RE: **Lot 8A Block 5 Unit 18 SAD 228
8004 Compass Dr. NW
Volcano Cliffs Subdivision
Grading and Drainage Plan
Engineers Stamp Date 10/11/2020 (D10D003K8A)**

Based upon the information provided in your submittal received 10/14/2020, this plan is approved for Grading Permit.

DRAINAGE AND TRANSPORTATION INFORMATION SHEET (REV 6/2018)

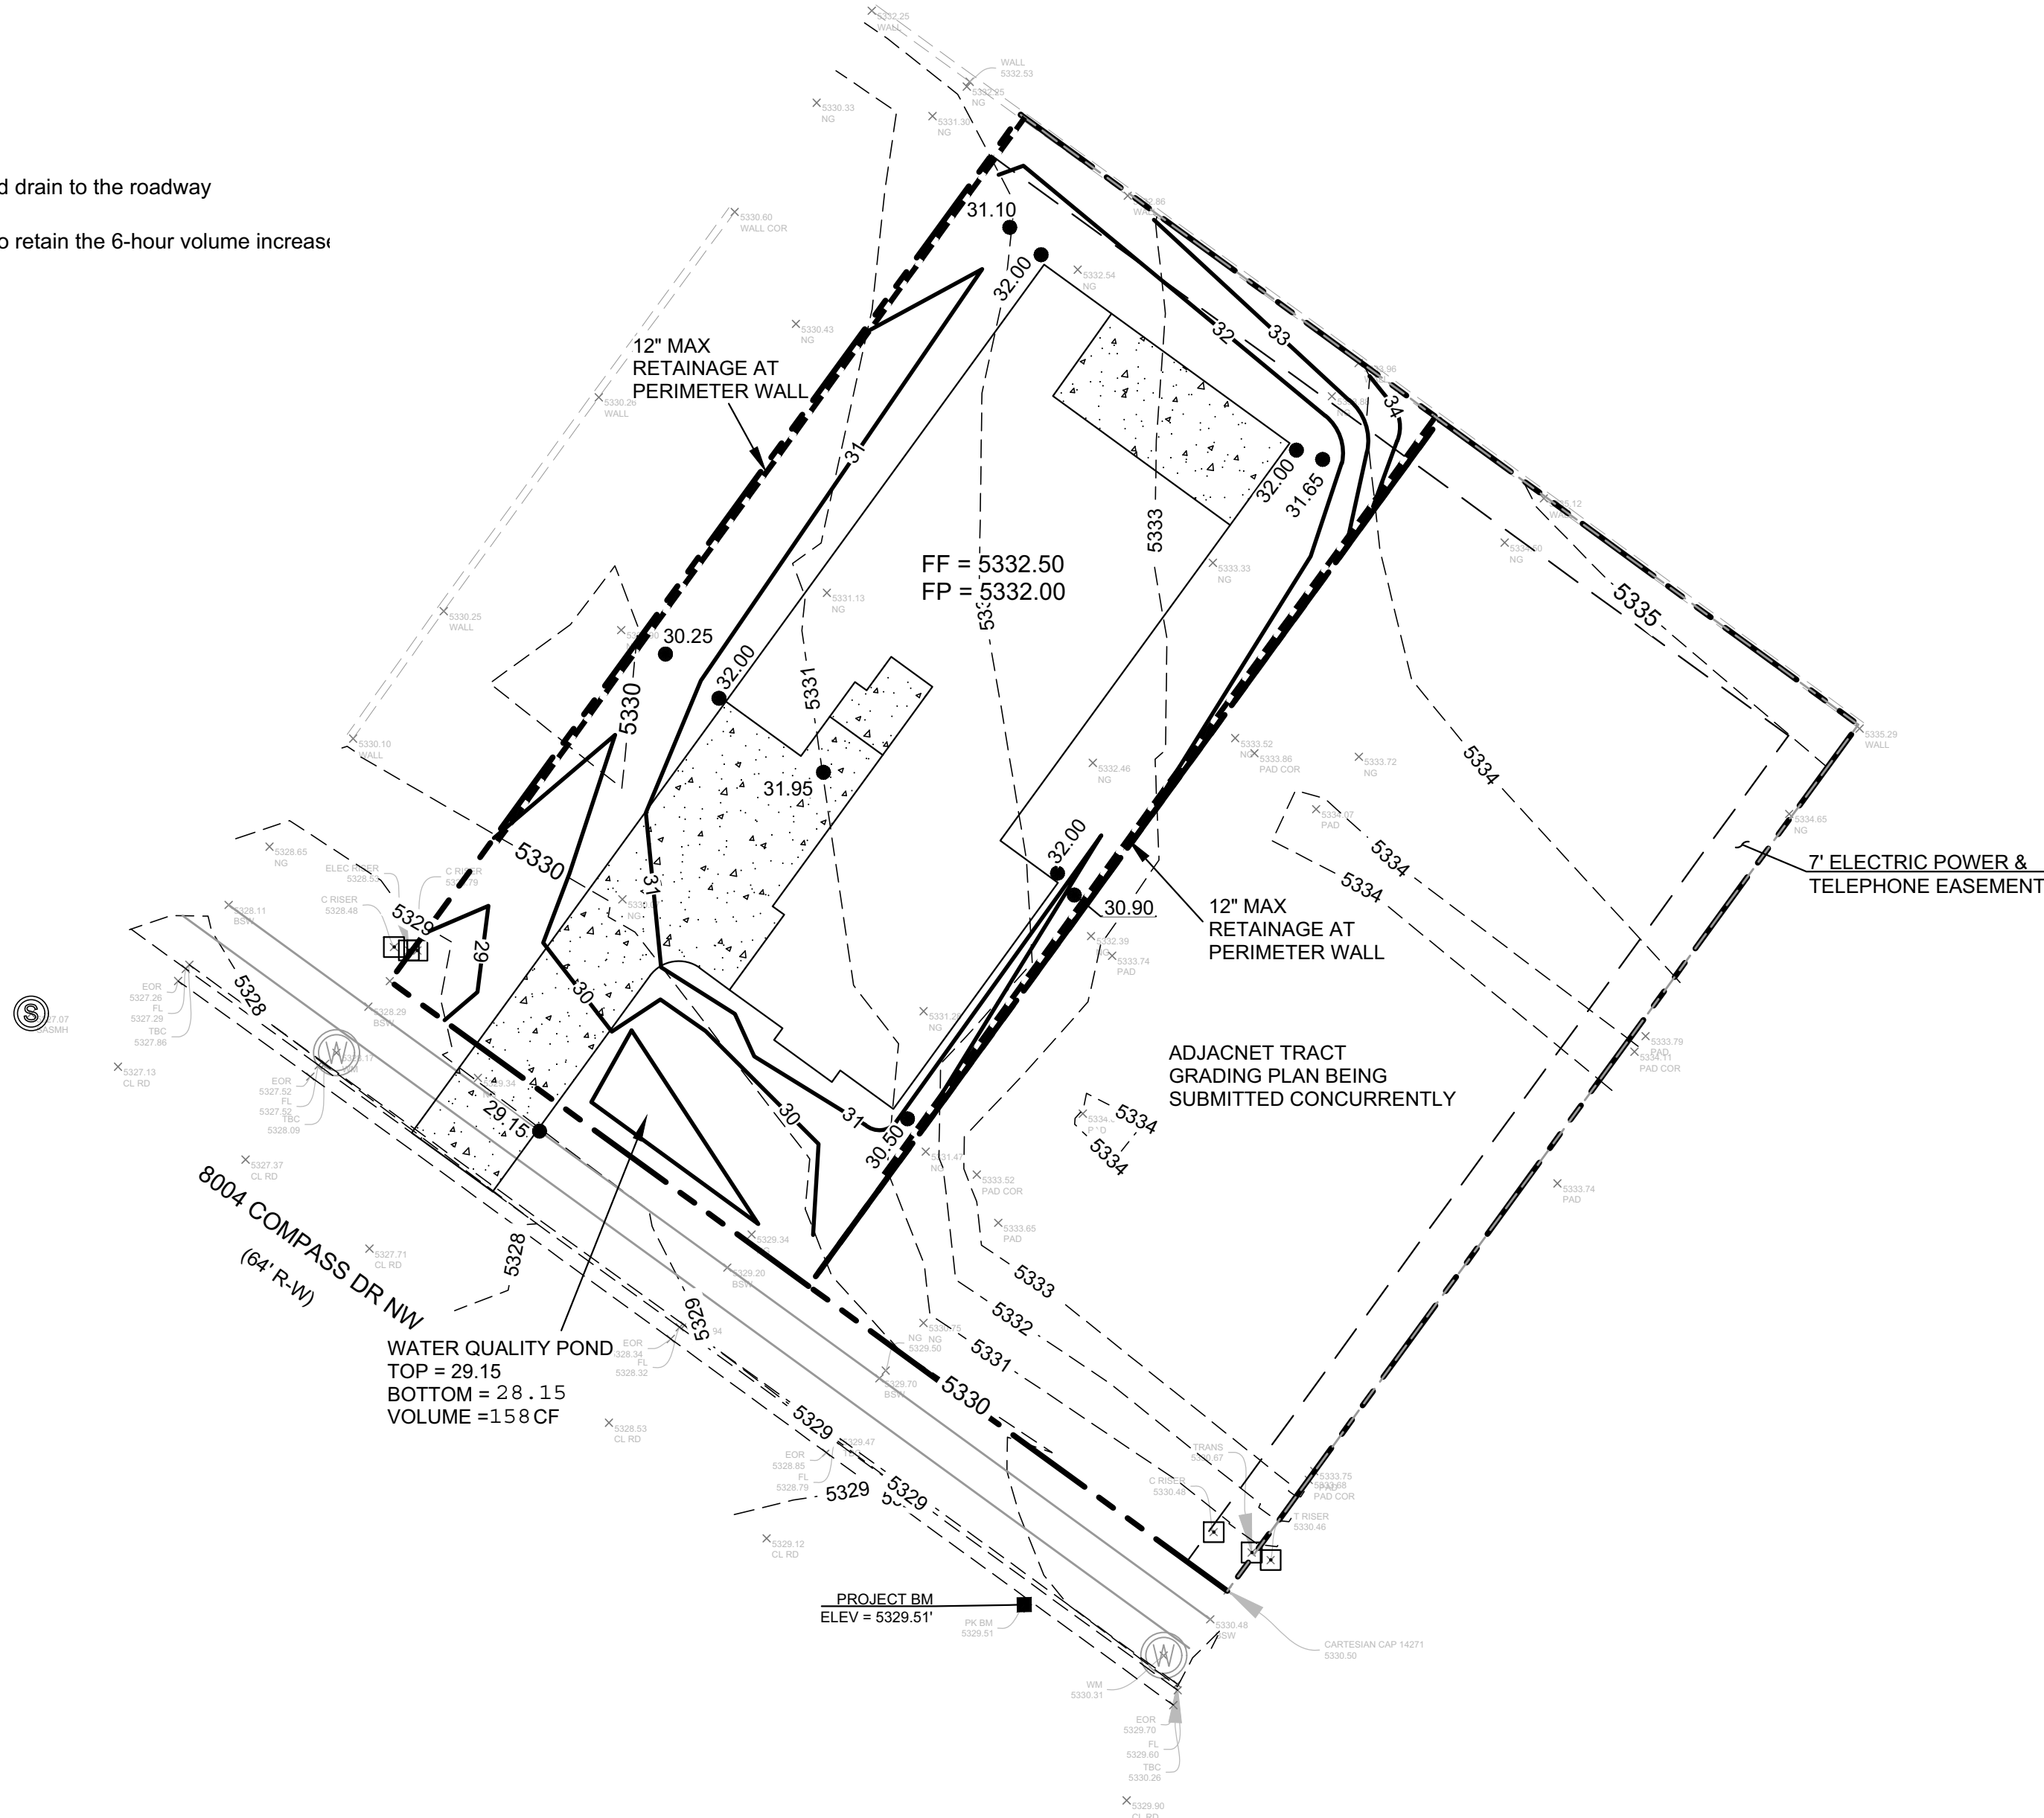
Prior to Building permit approval a Pad Certification will be required, provided by the Engineer or a registered Land Surveyor.

Advise the owner contractor not to use dirt as a ramp to climb the curb, use lumber or crusher fines for this purpose.

Reiterate to the Owner/Contractor that a separate permit for a garden/retaining wall must be obtained with the approved G&D plan and Pad Certification. Also, if a swimming pool is to be placed the grading and drainage plan will change and will need to be resubmitted.

Prior to Certificate of Occupancy release, Engineer Certification per the DPM checklist is required.
